Product Change Notification

Change Notification #: 114934 - 00
Change Title: Intel® Server System R2312WTTYSR
PCN 114934-00, Product Design,
Change dimension on PCIe* riser bracket
holes. Removed top screws, changed length of
top cover.
Date of Publication: September 30, 2016

Image 1. PCIe* bracket holes

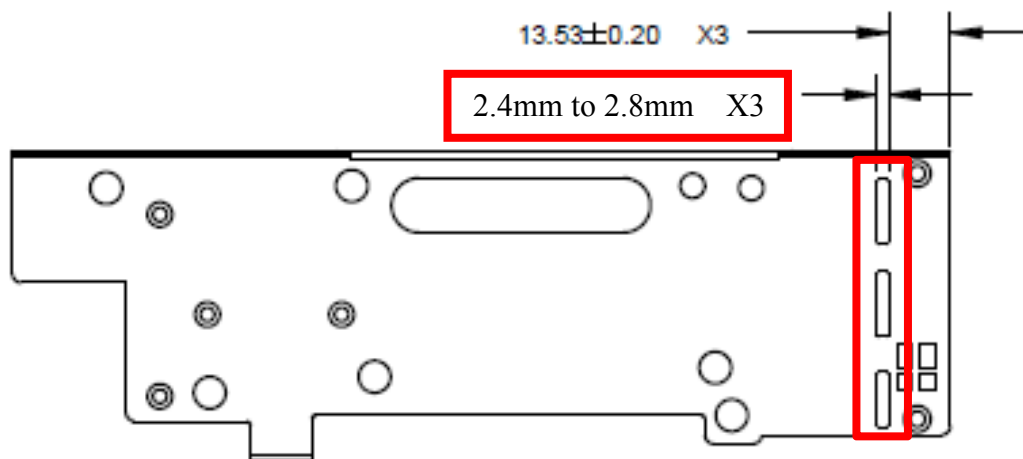
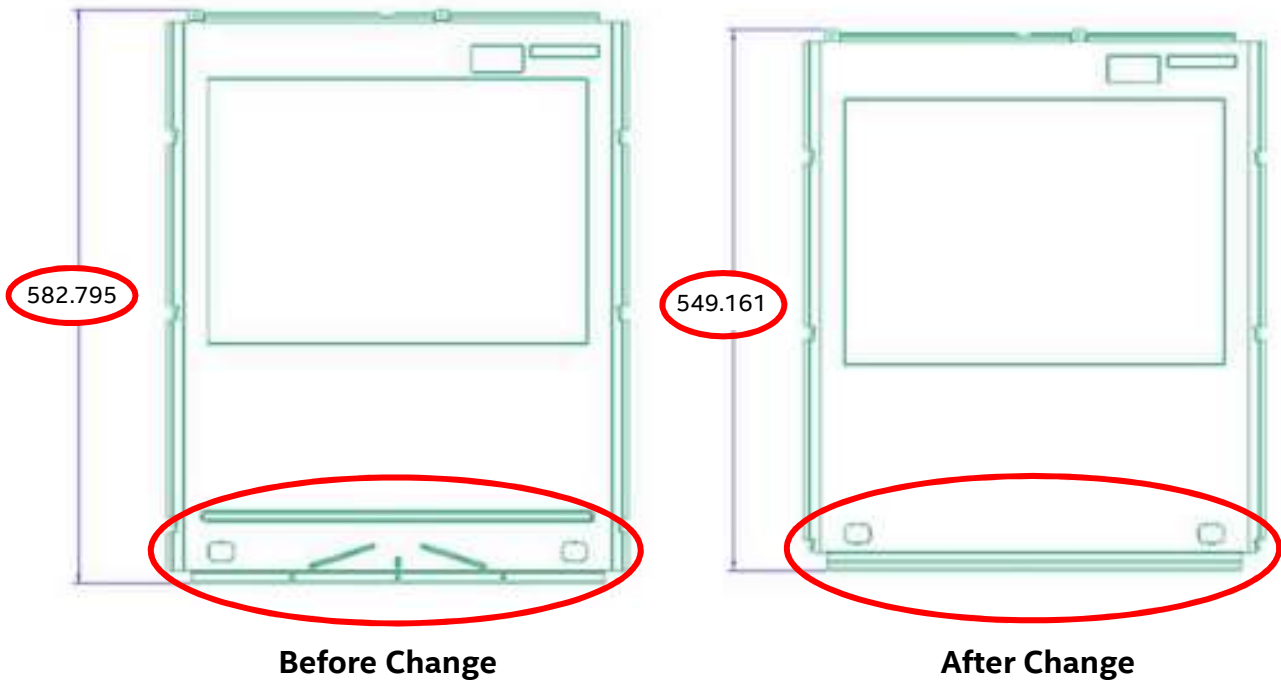
1. Intel is implementing the following change on the Intel® Server System R2312WTTYSR.
 - The width of the holes in the PCIe* Riser bracket change from 2.4mm to 2.8mm. Please see Image below for details.

This change will eliminate any difficulty with customers installing PCIe* cards in riser 2 and riser 3 on opposing PCIe* slots.
